NOTICE TO PROSPECTIVE BIDDERS
RI CONTRACT NO. 2025-CB-031
TCB25005700
Corridor - Woonsocket
ADDENDUM NO. 2
September 30, 2025

Prospective bidders and all concerned are hereby notified of the following changes in the Plans, Specifications, Proposal, and Distribution of Quantities for this contract. These changes shall be incorporated in the Plans, Specifications, Proposal, and Distribution of Quantities, and shall become an integral part of the Contract Documents.

WOONSOCKET CORRIDOR
VOLUME: 3
BRIDGE 095301 - STEEL REPAIR DETAILS - 1

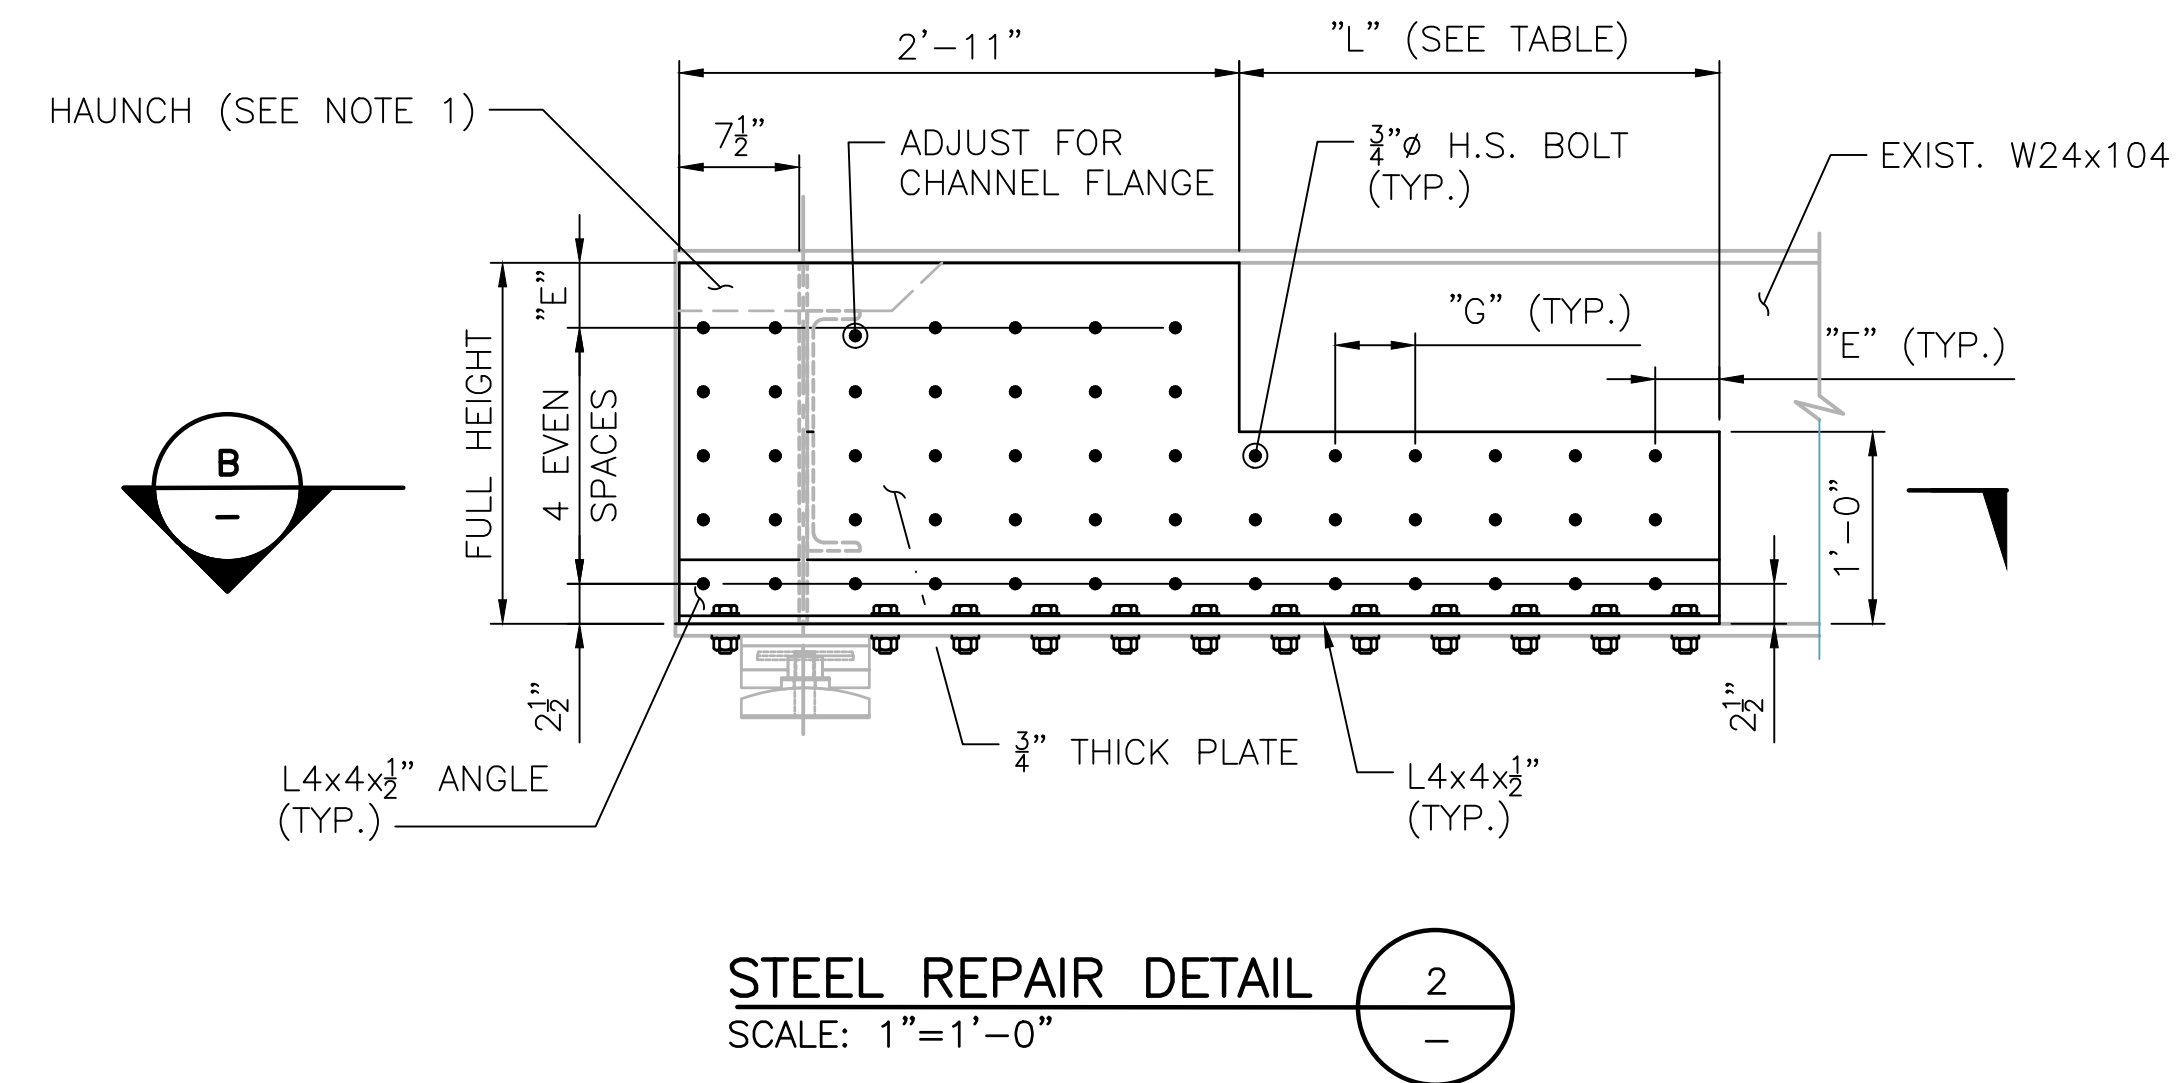
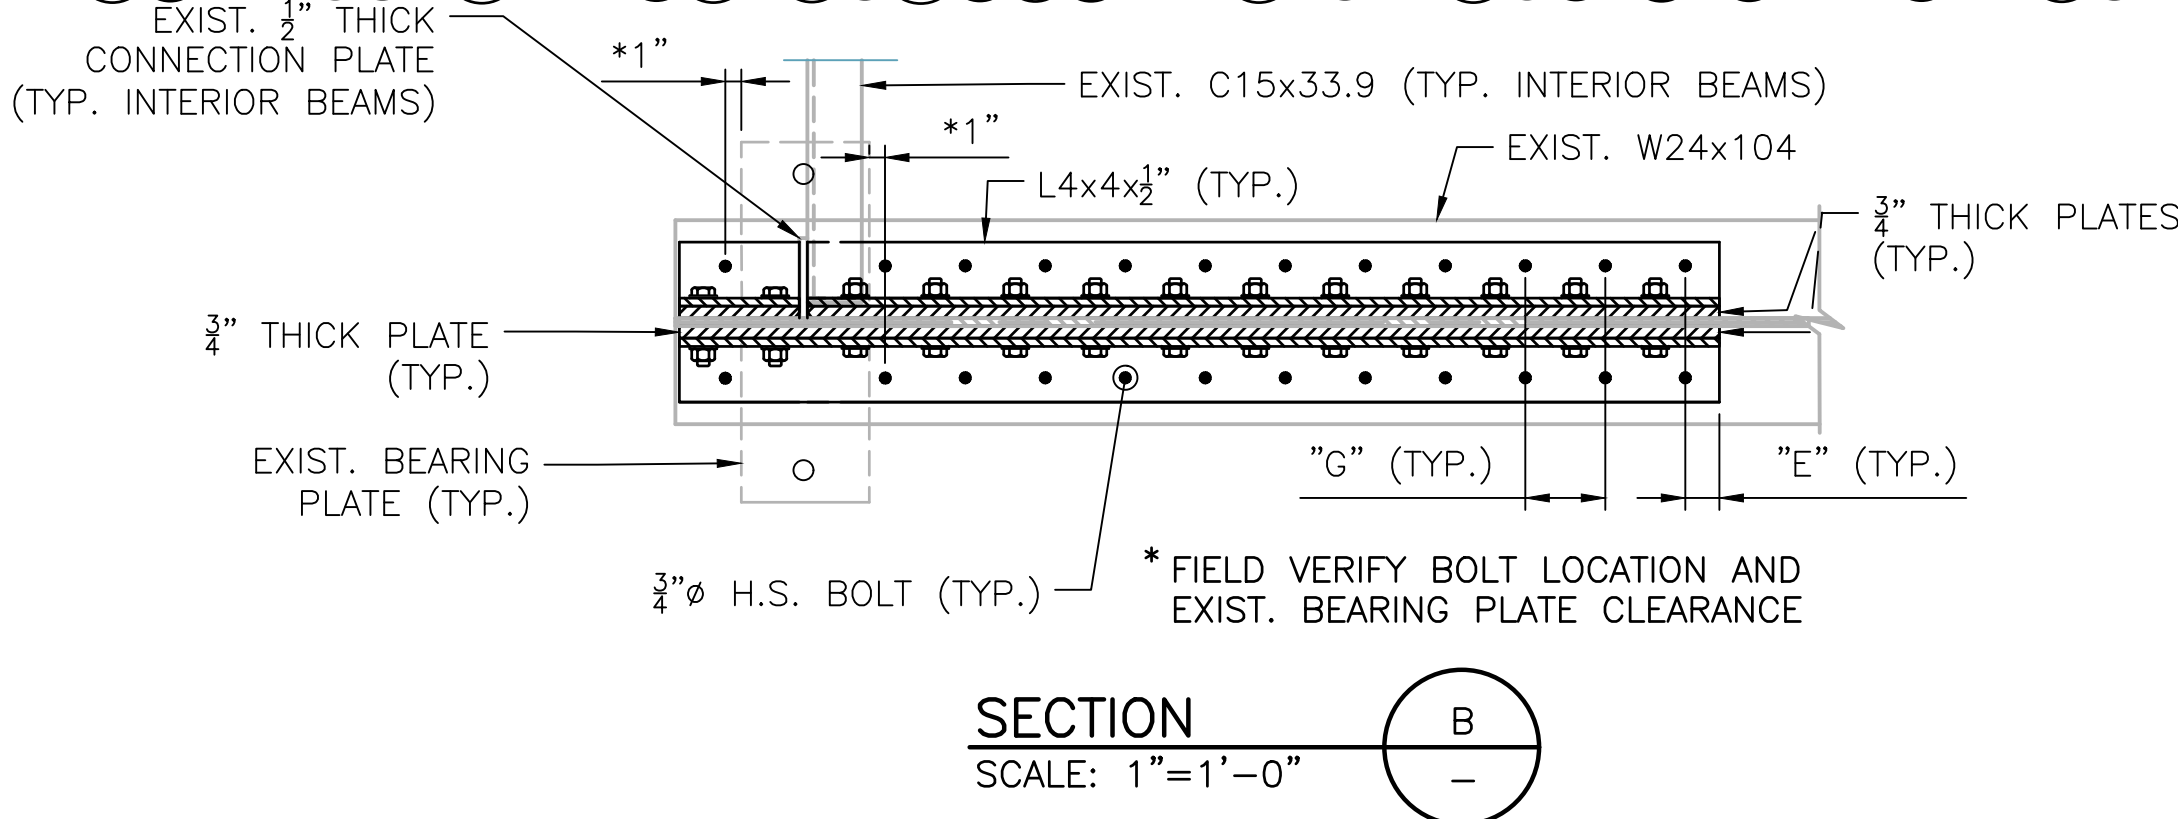
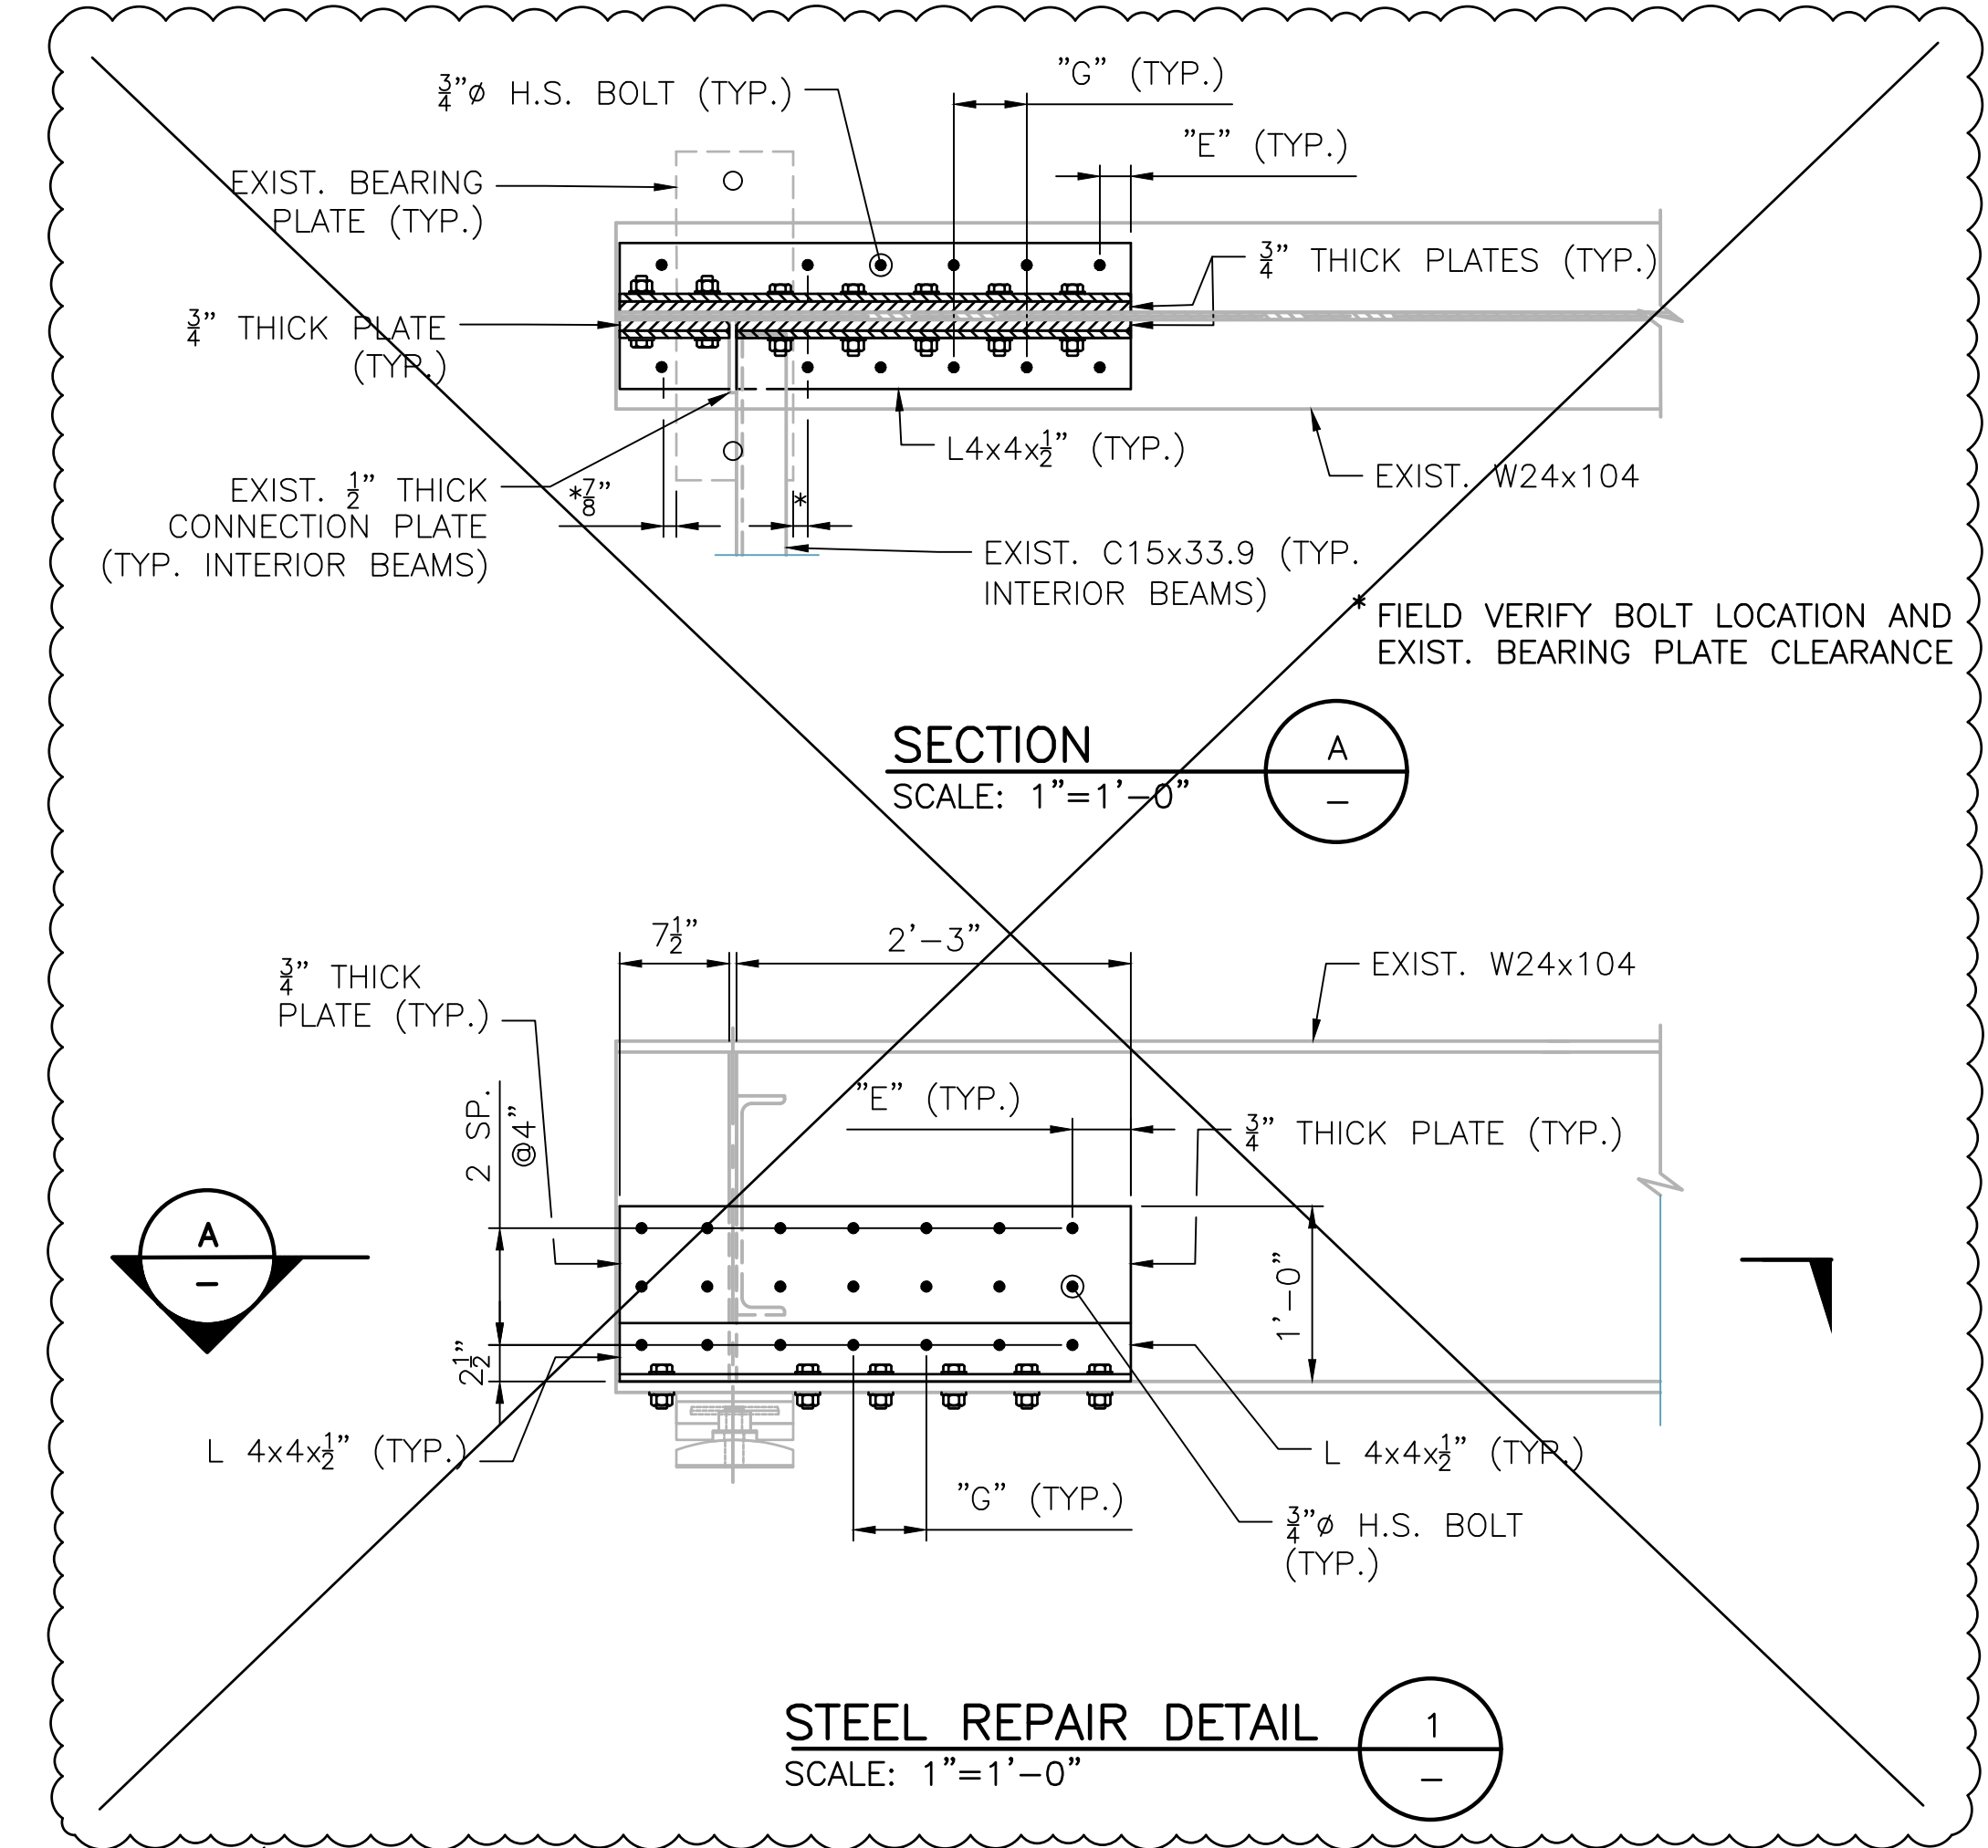
Question Ask By	Question	Answer	Date Submitted	Date Responded
Aetna Bridge Company	Bridge 095301, Sheet 37 has a steel repair detail 1 but the framing plan does not indicate a location for repair detail 1. Please confirm if there is a repair using this detail and the location(s)?	This detail will be removed from the plans by addendum.	Sep 25, 2025 4:27 PM	Sep 29, 2025 3:53 PM
Aetna Bridge Company	At Bridge 068801 the existing dam appears to have extensive deterioration but the drawings do not call for any repair work other than the pressure grouting at the interface with the apron. Please confirm there are is no repair work to be done on the existing dam structure.	No repair work, other than what is shown in the Plans, is proposed for the dam structure.	Sep 25, 2025 4:24 PM	Sep 29, 2025 3:53 PM
Aetna Bridge Company	All the water crossing bridges contain varying quantities of debris that is within the limits of work in the channel. The scopes call for removal and disposal at several of the bridges but does not say how the work is paid except at bridge 068801 which says the work is incidental to Item 201.0321 Clearing and Grubbing. The work to remove the debris from the channel is unrelated to clearing and grubbing which is paid by the SY. Please consider paying for this work on either force account or by creation on a new item.	Removal and disposal of debris within the channel is only proposed at Bridge 068801. This work is considered incidental to Item Code 201.0321.	Sep 25, 2025 4:14 PM	Sep 29, 2025 3:53 PM

- WATER PIPE SUPPORT TO BE REPLACED IN-KIND. SEE EXISTING SUPPORT DETAILS ON PREVIOUS SHEET.
- NEW SUPPORT TO BE INSTALLED DIRECTLY ADJACENT TO THE EXISTING SUPPORT PRIOR TO REMOVAL OF THE EXISTING SUPPORT. LOCATION TO BE APPROVED BY THE ENGINEER.
- PAYMENT FOR THIS WORK SHALL BE INCLUDED UNDER ITEM CODE 824.9901.
